ENGINEERING ORDER

1. ENGINEERING ORDER NO. 2010C0691

2. DWG TITLE	3. DWG CAGE CODE	4. DWG NO.
Fuel/Oil Heat Exchanger	78943	UA538795-3

This EO adds Item Unique Identification (IUID) requirements to the drawing

UA538795-3 (REF)

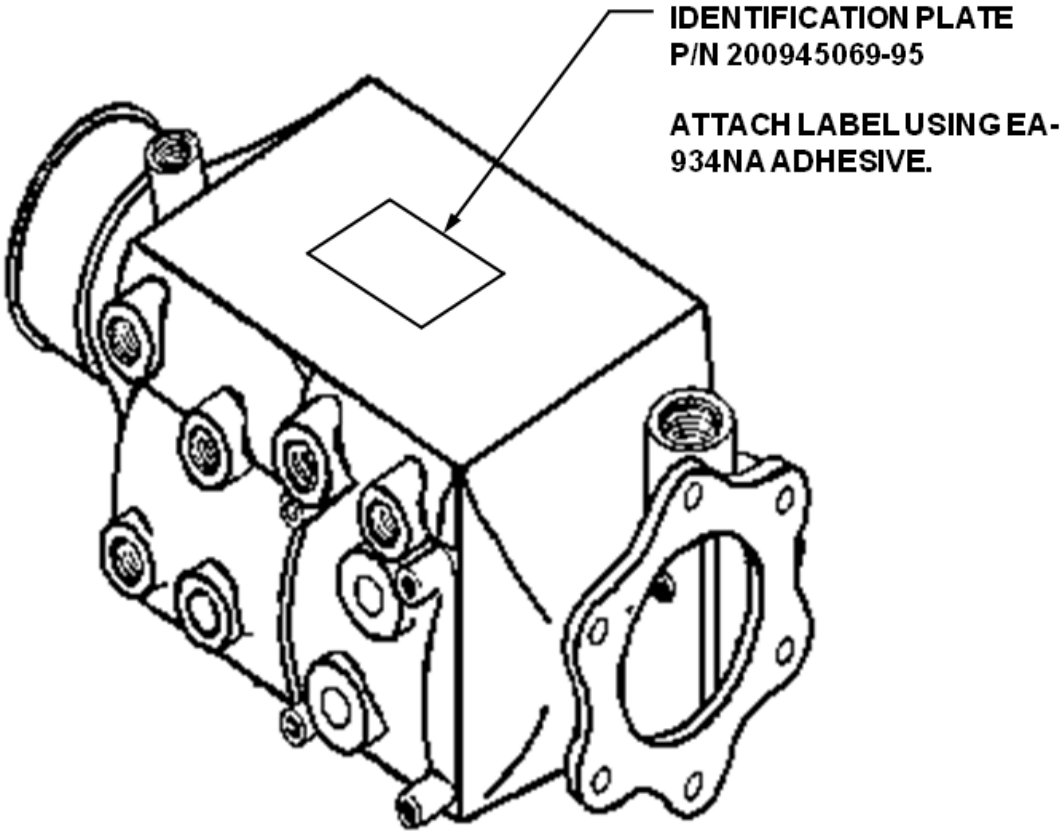
- If no UII matrix is present, fabricate new identification plate (200945069-95) and attach in the location of the existing ink stamped identification information using EA-934NA adhesive or equivalent.

- The new UID identification plate will be located on the end item as shown in sketch/photo on page 2, AF form 3926.
